Original Comments 151-160

State Water Resources Control Board
P. O. Box 100
Sacramento, CA 95801

Following are our comments to the proposed subchapter 16, Regulations for Storage of Hazardous Substances, chapter 3, title 23, California Administrative Code. We request that these comments become part of the rulemaking file to be submitted to the Office of Administrative Law.

Figure 1: Stage I Vapor Recovery And Separate Product Drop.

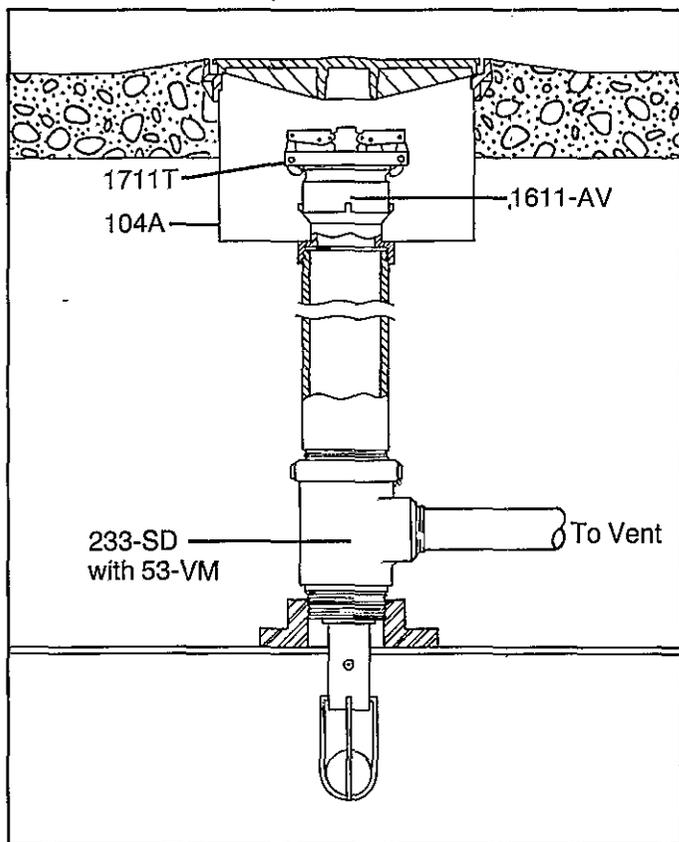
I am enclosing a copy of a typical ball float vent valve system which is shown in the OPW Brochure OPS-84. The system shown in Figure 1 corresponds to the OPW A-7 Stage I Vapor Recovery System. The Stage I vapor recovery portion of this has been approved by the California Air Resources Board (a copy of Air Resources Board Certification G-70-2-G is attached). This system using a ball float valve has also been approved in other parts of the U.S. for overfill protection and we believe this type system allowing for a simple, trouble-free overfill protection should be allowed in both Paragraphs (f) and (g) referred to above.

This shows a system where Stage II vapor recovery is not required and utilizes the OPW 1611-AV for Stage I vapor recovery mounted above a 233-SD (includes OPW 53-VM). Access is readily available to the 53-VM for extraction.

Figure 3

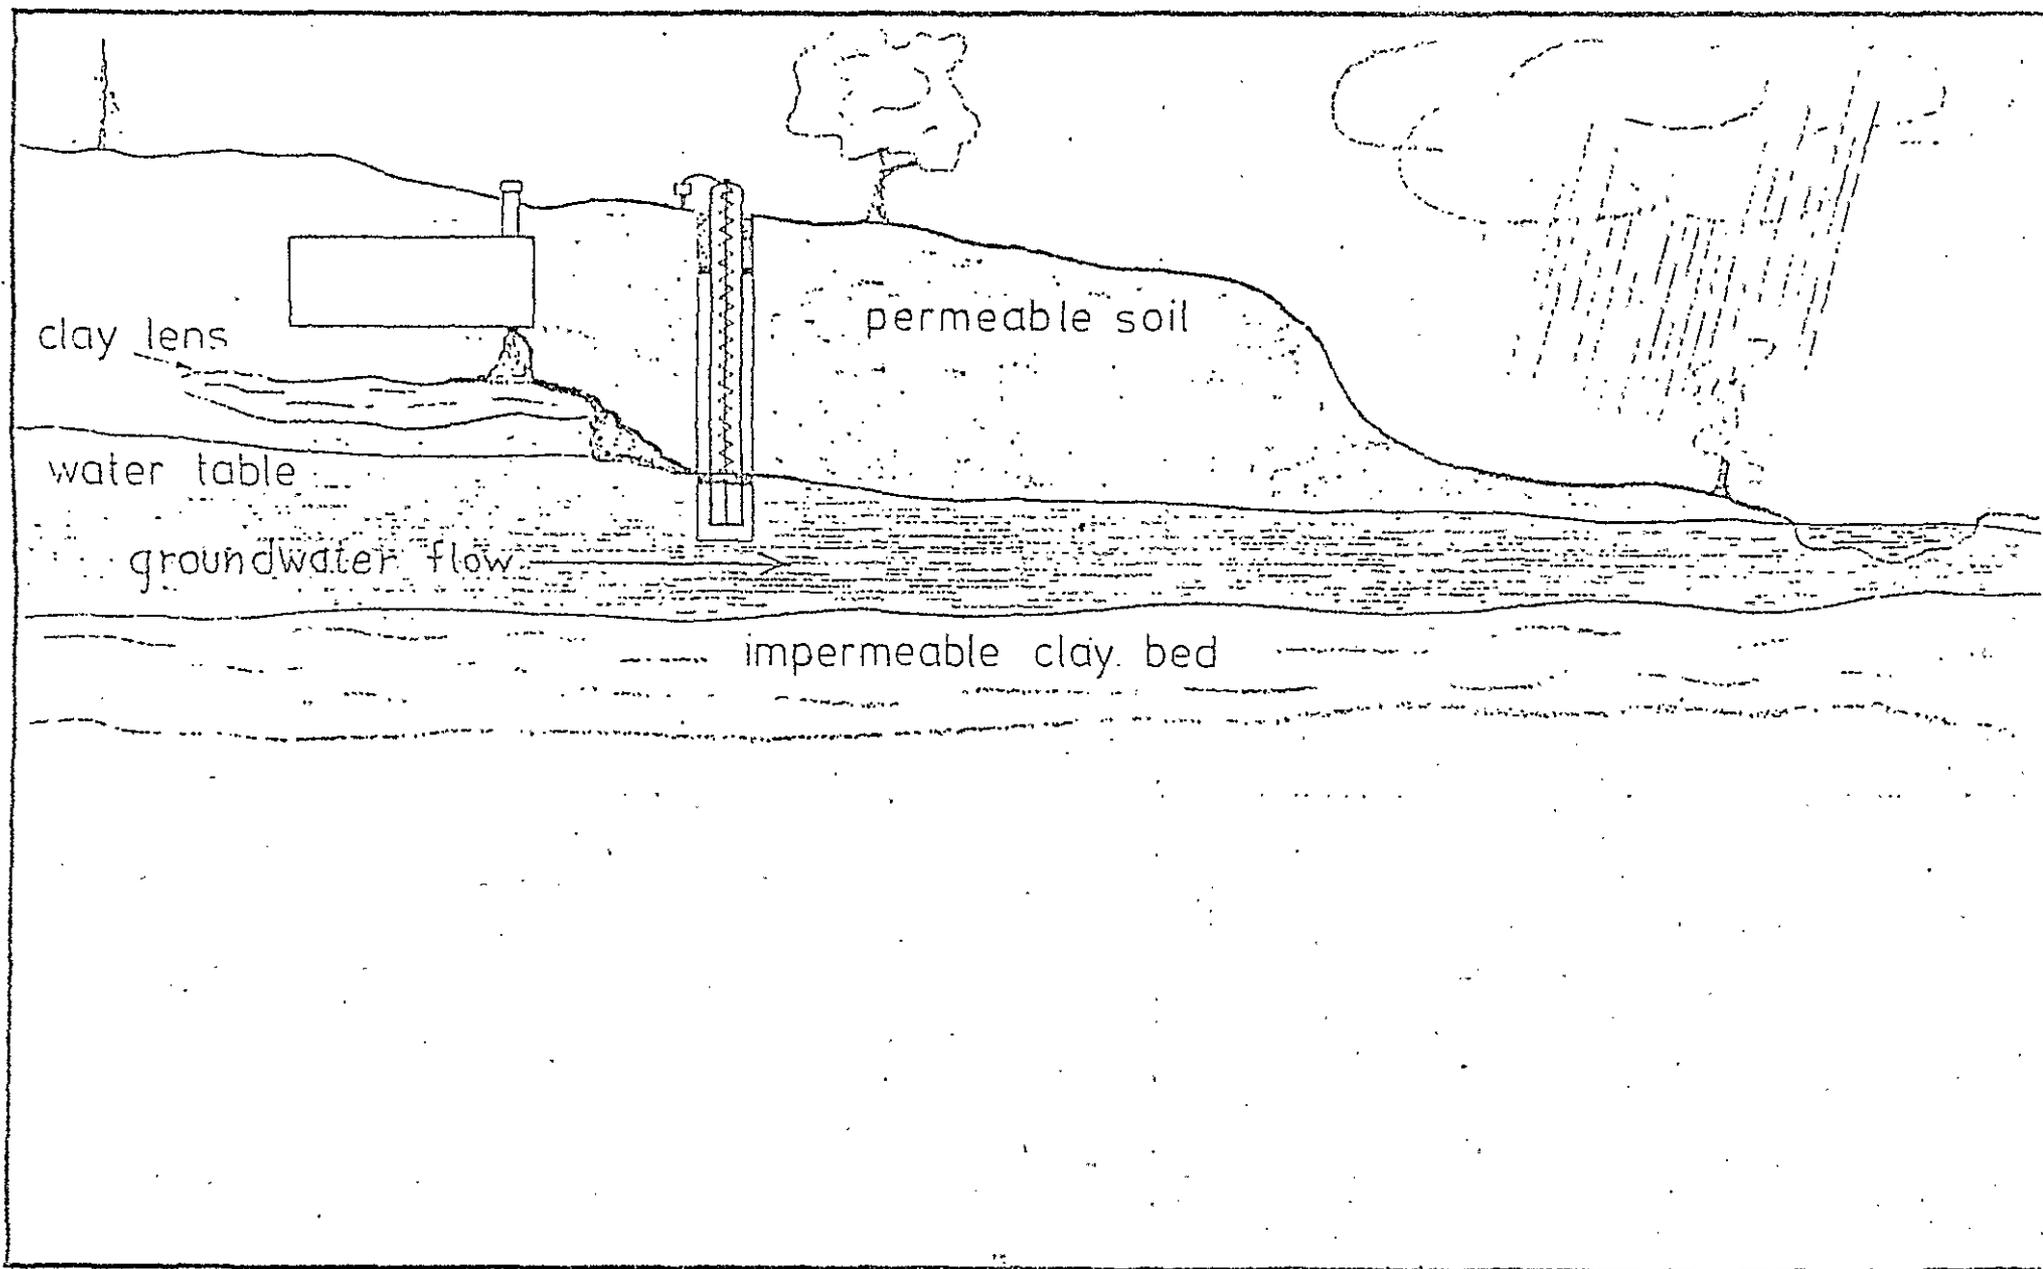
Figure 3 shows how a groundwater monitoring well, down gradient from an underground tank, would detect a leak.

Figure 5

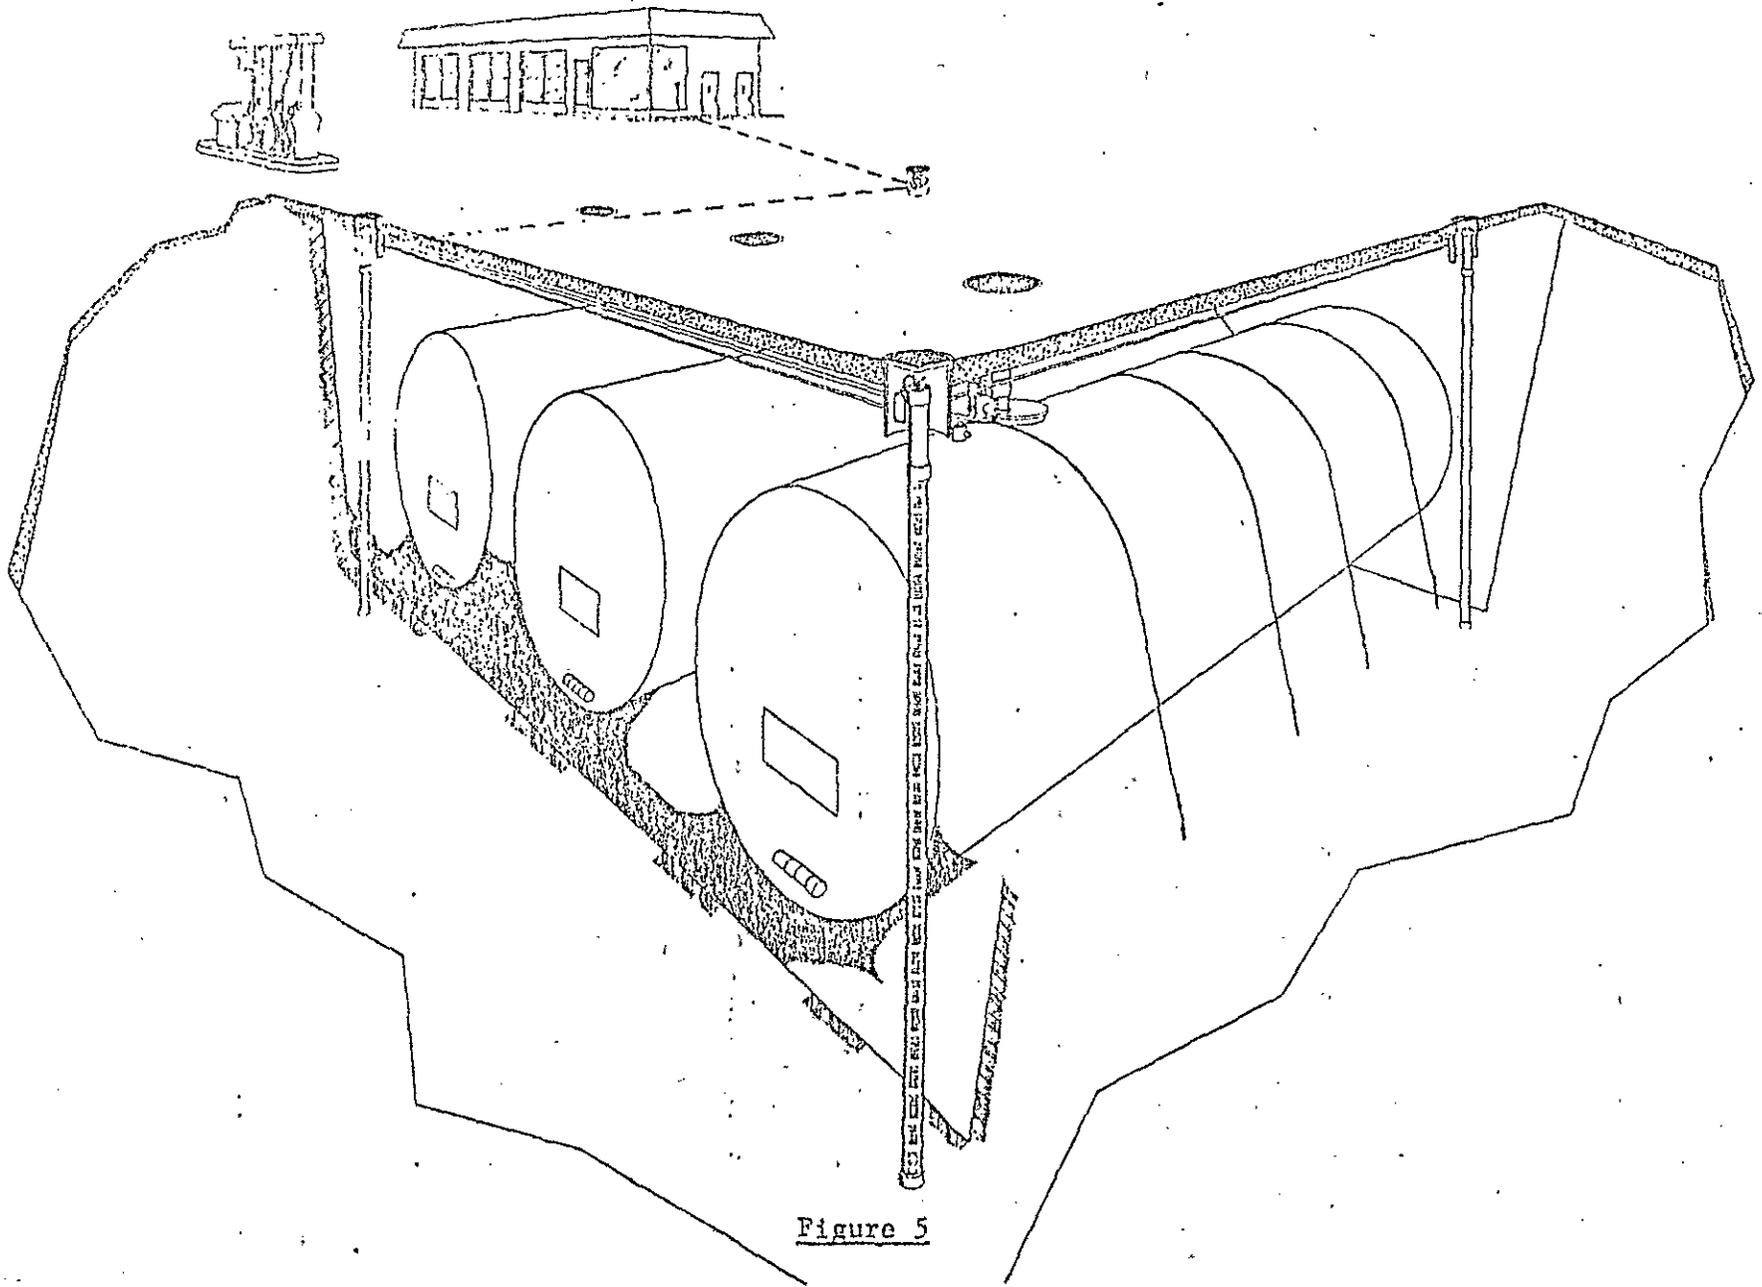
An ideal way to monitor the sites of buried underground hydrocarbon storage tanks is to have the monitoring wells located in the same cavity or excavation in which the tanks were installed as shown in Figure 5. If a leak were to occur in one of the tanks, the product would move vertically until the concrete slab used for tiedowns is reached. The concrete slab can be considered an impermeable bed or lens, so that the product would have a tendency to spread laterally until it reaches immobile saturation, or if the leak continues, until it reaches and enters one of the monitoring wells.

FIGURE 7

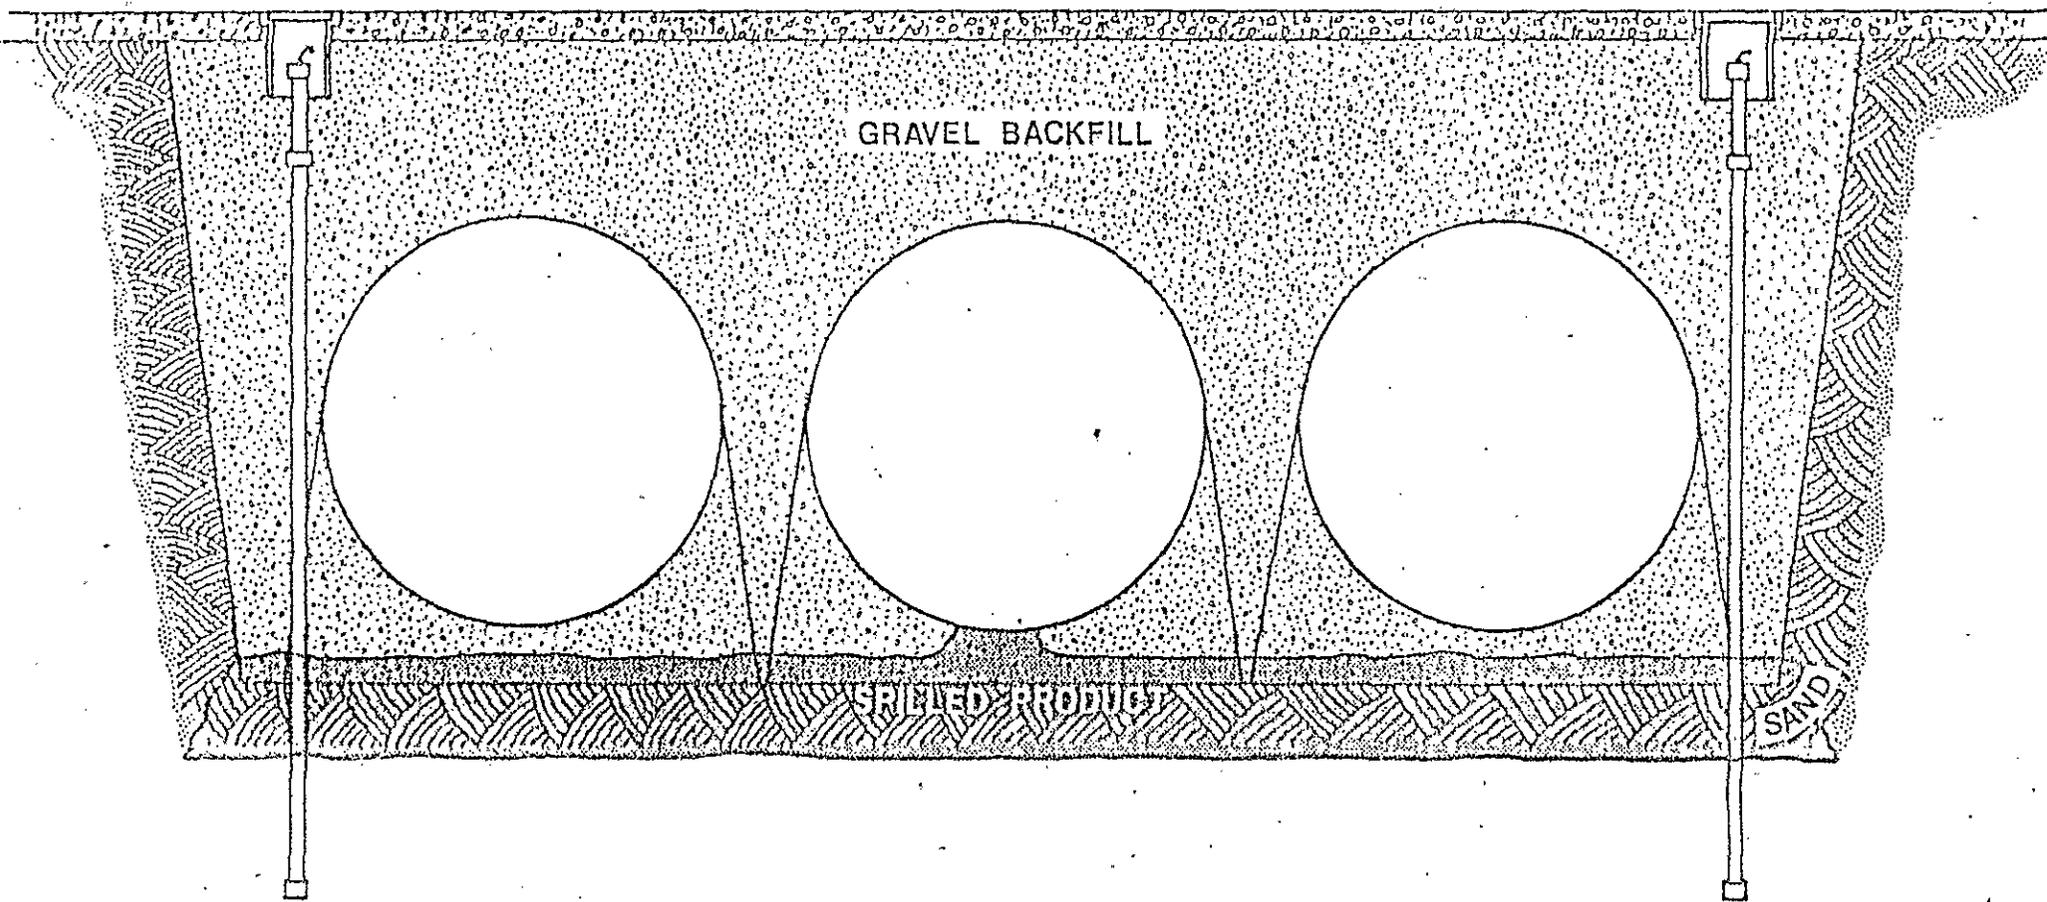
What if the installation did not use a concrete slab for the tank tiedowns? The next best situation is where the tank excavation is in a clay soil, and no concrete slab exists (Figure 7). Again, the monitoring wells extend several feet below the gravel/clay excavation interface. Using the values from the permeability table mentioned previously, the clay soil is considered to be a continuous impermeable layer, and again would inhibit vertical movement of the leaking hydrocarbon and force the lateral movement towards the wells.
